2015/3268/P	21 Swain's Lane	Installation of a steam extract to rear outbuilding roof level and addition of a louvre door to existing outbuilding in connection with retail unit (Class A1).	Matthias Gentet
-------------	-----------------	---	-----------------

Object due to inaccurate information

Advisory Committee	Holly Lodge
Application ref	2015/3268/P
Address	21 Swain's Lane London N6 6QX
Planning Officer	Matthias Gentet
Comments by	20 May 2016
Proposal	Installation of a steam extract and terminal vent to rear outbuilding roof level, and addition of a door to existing outbuilding and associated alterations in connection with retail unit (Class A1).
Objection	Yes
Comment	Yes
Observations	See attached document

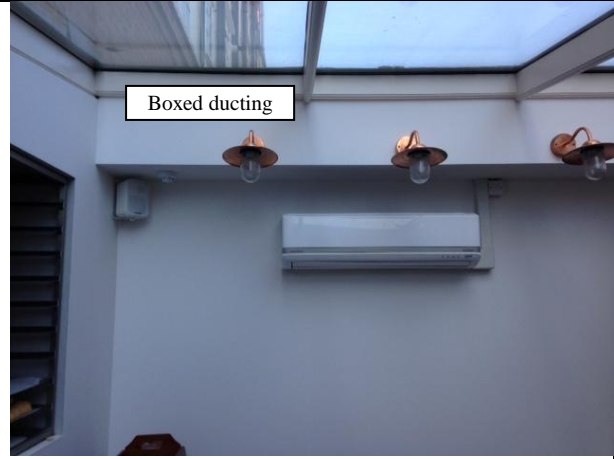
A - Start of system, hood over hob, fan in horizontal leg, no carbon filter

B - Boarded duct housing 200mm pipe in conservatory, are attenuators installed?

C - Terminal vent above AC outhouse

D Terminal from above

extracting air from above the hob, not the oven (photo A). The DAS continuously refers to it as a domestic kitchen extract, at 200mm dia ducting & with a 250mm fan it is large for a domestic unit.

The carbon filter & fan are shown installed in a dog leg of the ducting (drg 1100 R02), this does not exist, see photo A, thus the description 'retrospective Planning Application' is incorrect.

No details of the Tecsound attenuators are included in the application (however details can be found at <http://plan.scambs.gov.uk/swiftlg/MediaTemp/1130037-482544.pdf>) nor is the number of attenuators stated. Drawings from the earlier application (Dec 2015) omitted these units and where shown on the current drawings they would be within a plaster boarded duct and thus not be visible (photo B). If claimed that these attenuators are installed proof should be demanded.

Drawing 1100 R02 indicates this system terminates with a Helios HQ 1 ph (230/1/50) motor above the AC plant room though it is also described as being the 'plant area extract' which is believed to be its correct function and is within the Weatherform Roof Mounted Terminal. Photos C & D show the existing termination details, a weather cowl.

Contrary to the statements in the DAS that terminating this ducting above the AC room roof is the optimum location this exhaust would be better located within the AC plant room. Located as it is now, 5m or so from the windows of the neighbouring apartments, it is both unsightly and threatening, hidden within the plant room it would better meet DP26.

The termination point of the ducting from the hood should also be relocated to within the AC room to eliminate the unwelcomed visual impact of this exhaust.
